CONDITIONS OF APPROVAL:

Engineering - Final Plat Checklist

554716056_2019-07-08_Berry Farms - Section 10 Revision 2_Lot 1003.pdf

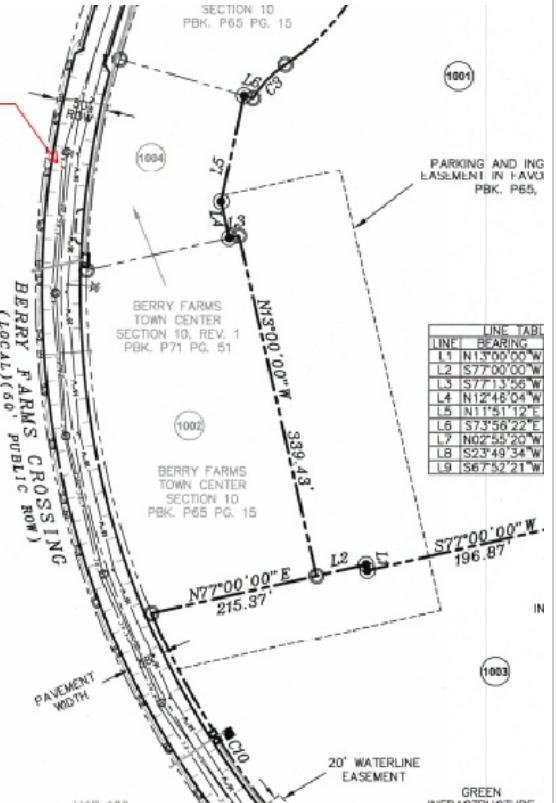
ben.mcneil@franklintn.gov The applicant shall provide the size of the existing infrastructure shown on the proposed plat.

The applicant has labeled the utility sizes, but the reclaim water main extending through Berry Farms Crossing is an 8", the applicant shall revise.

8" reclaim waterline

zdavis@smeinc.com sizes of utilities are now shown
